Year 3 Monitoring Report

LITTLE SEBASTIAN SITE

NCDMS Project # 100027 (Contract # 7187) | RFP 16-006993 (Issued 9/16/2016)
USACE Action ID: SAW-2017-01507 | DWR Project # 2017-1041

RE: Little Sebastian, Project ID #100027, DMS Contract #7187

MY3 Little Sebastian GW1

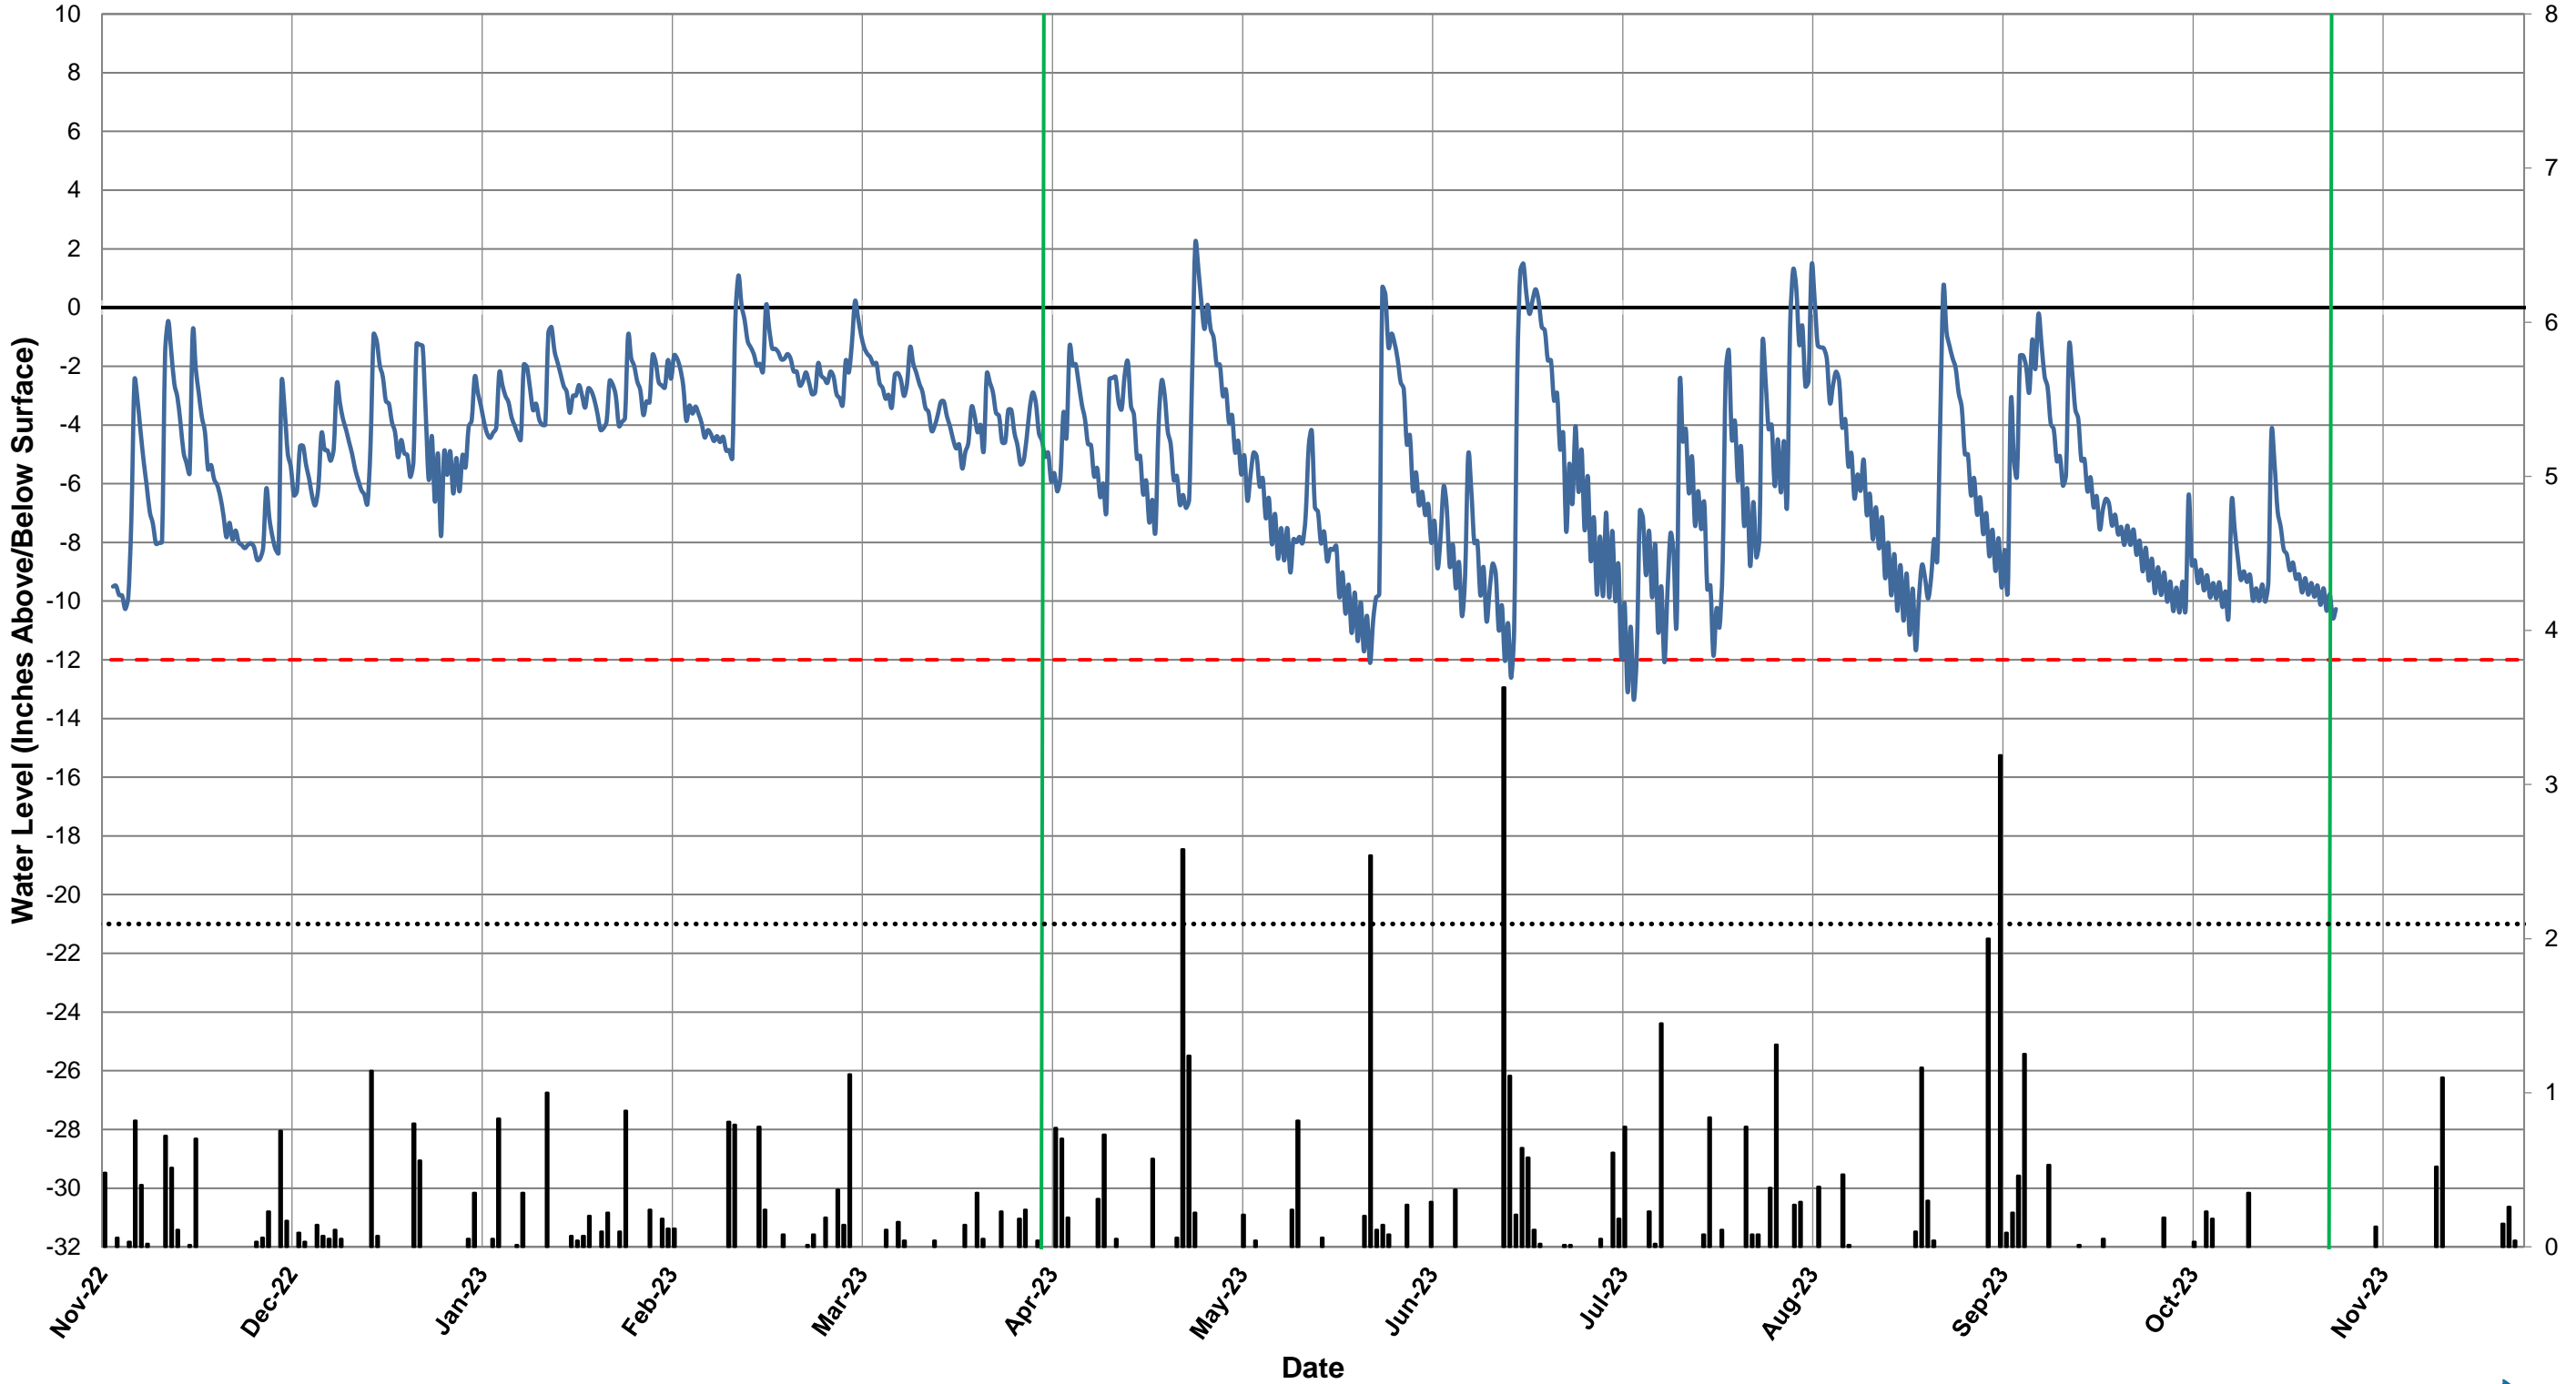
14. MY3 Little Sebastian GW1 Graph: The report text indicates that GW1 recorded a consecutive hydroperiod of 100 percent of the growing season; however, the graph shows several instances where the water level drops below -12 inches during the growing season. Please review the data and update the report and graph accordingly.

The groundwater level does drop below the 12-inch mark during the 210-day stretch; however, the groundwater gauge reads twice a day, and each of the instances where the level drops below 12 inches, it is only for one reading that day, not both. RES determines a consecutive streak by beginning with at least two days of readings above 12 inches, and then at least one reading a day above the 12-inch mark, until there are two readings in a row under 12-inches, ending the consecutive day count. Please reference the GW1 raw data in the digital files (5. Hydrology Data) to see where the determinations come from.

MY3 Little Sebastian JN3-B Stage Recorder Graph

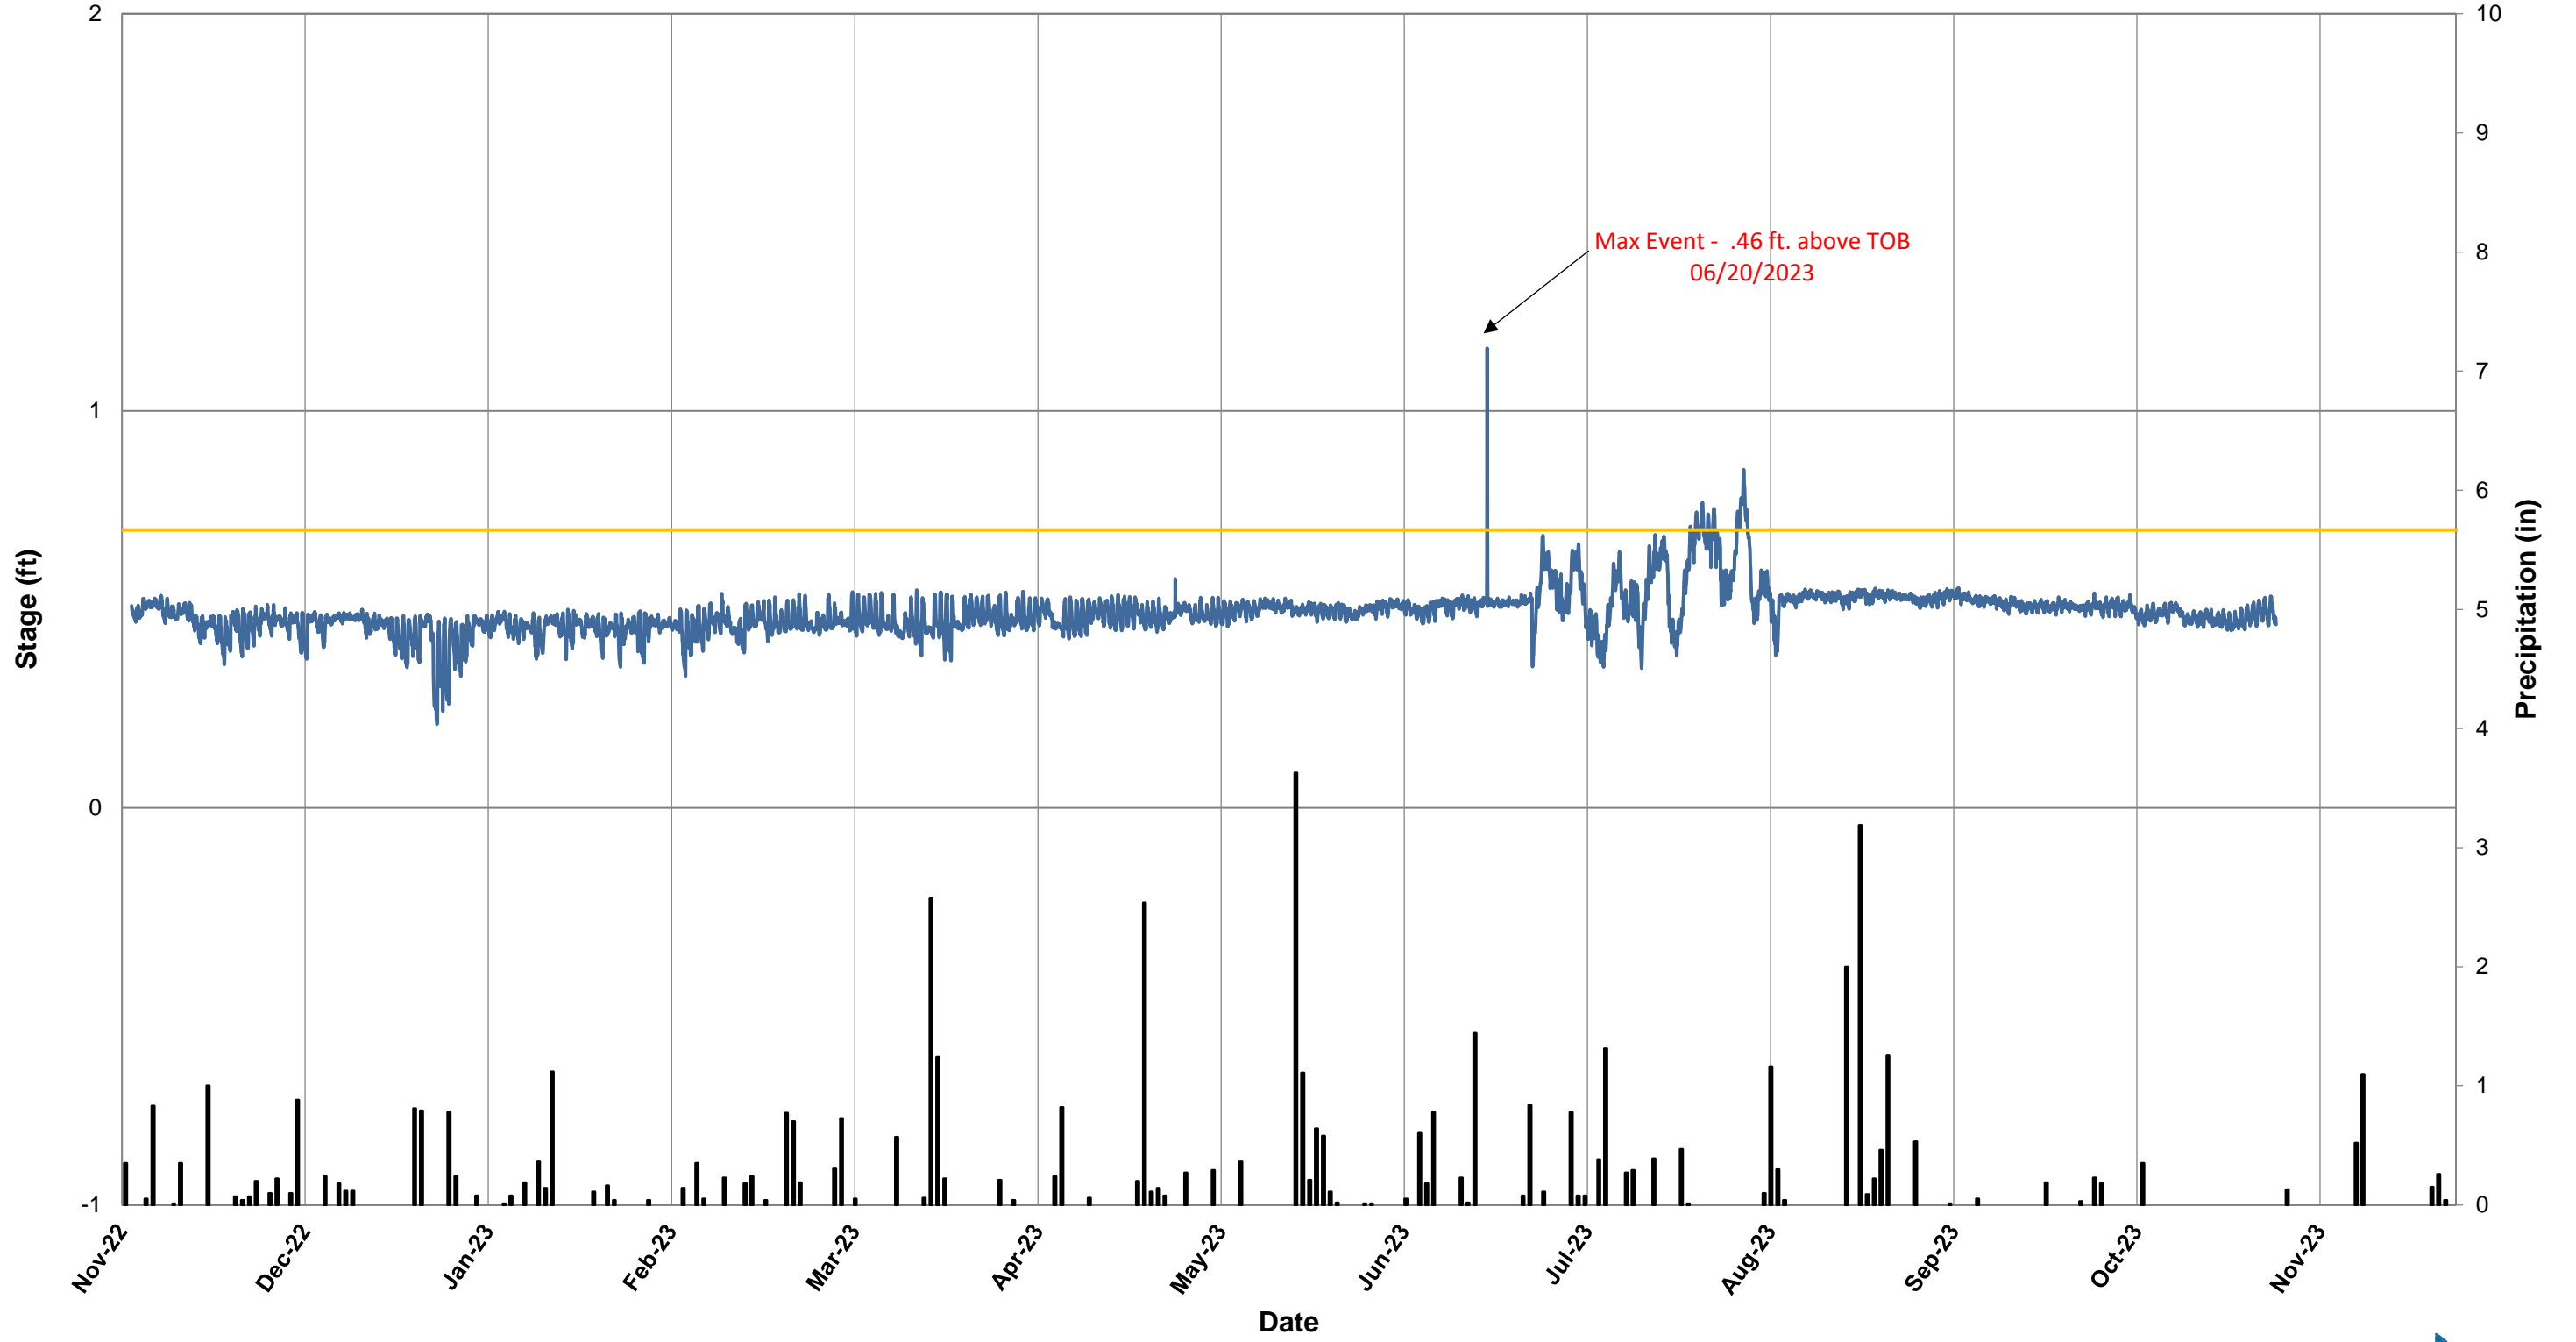
15. MY3 Little Sebastian JN3-B Stage Recorder Graph: The legend for the graph is incomplete. Please update the legend accordingly. Please review and confirm that the Max Event reported is correct based on the Stage (ft) scale. It is difficult to determine with limited Stage (ft) lines shown on the graph. Please review the graph and MY3 project data in detail and confirm the reported information is accurate.

The legend has been updated accordingly. JN3-B graph and data have been reviewed and confirm that the information is accurate.

MY3 Little Sebastian BS1-E Stage Recorder Graph

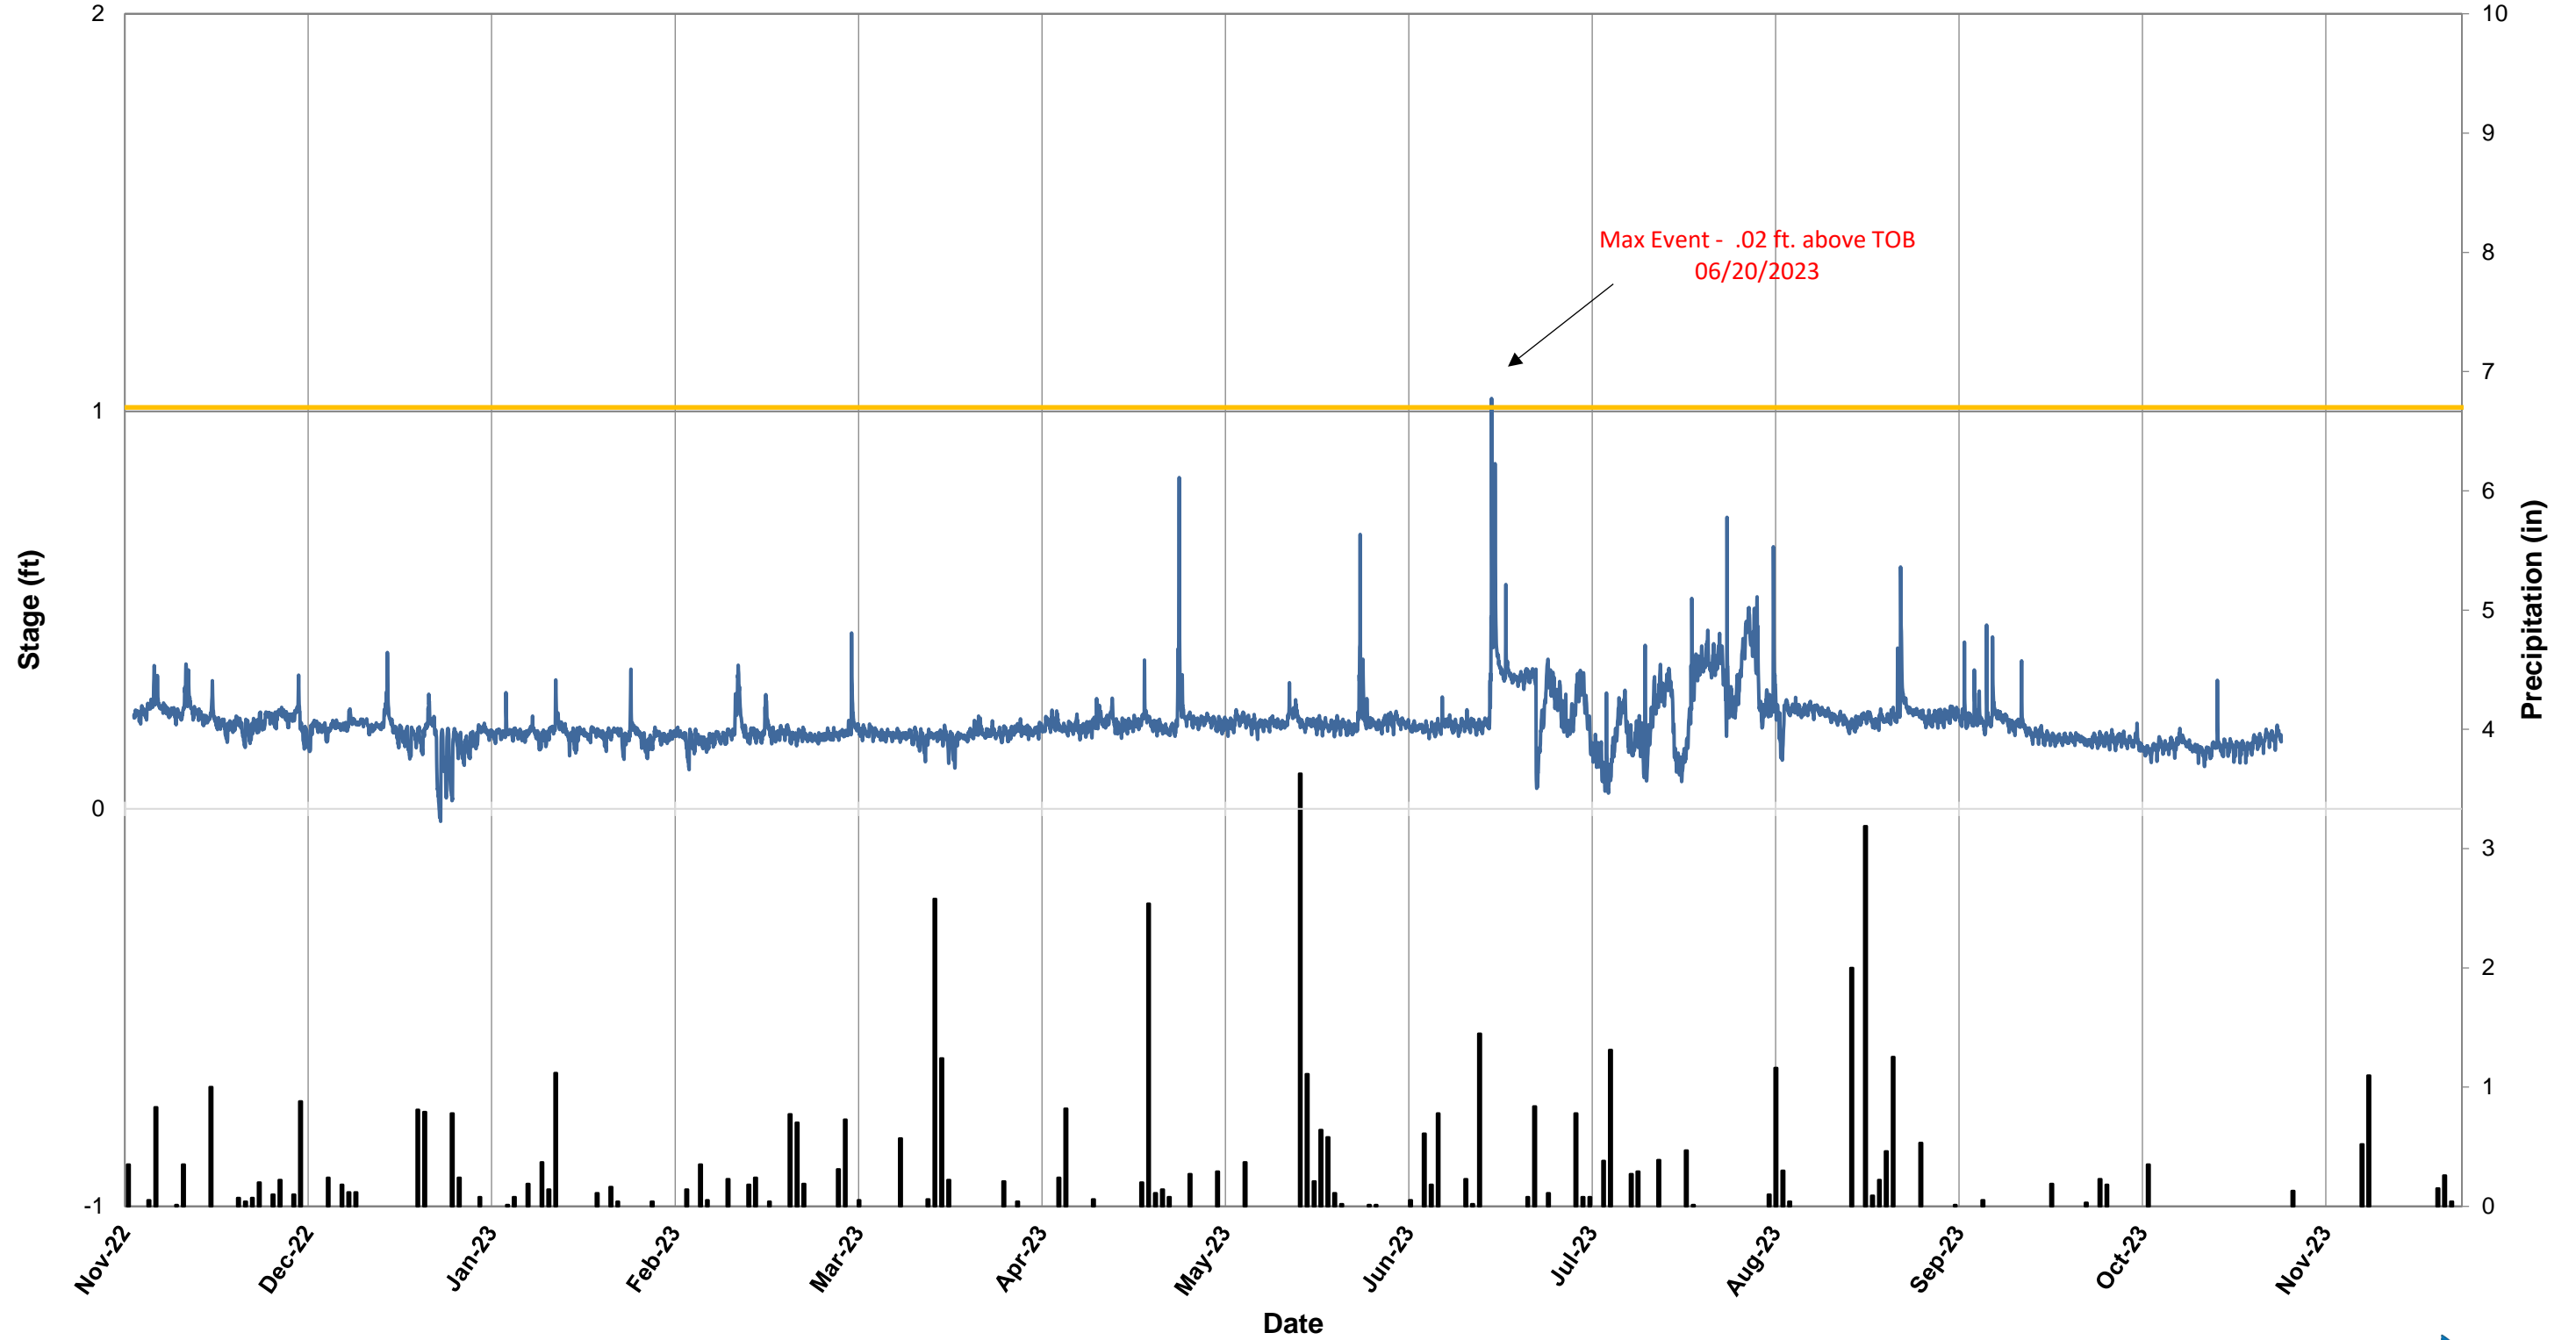
16. MY3 Little Sebastian BS1-E Stage Recorder Graph: Please review and confirm that the Max Event reported is correct based on the Stage (ft) scale. It is difficult to determine with limited Stage (ft) lines shown on the graph. Please review the graph and MY3 project data in detail and confirm the reported information is accurate.

BS1-E stage recorder has been reviewed and RES confirms that the max event on June 20th, 2023, was .02 feet above the top of bank.
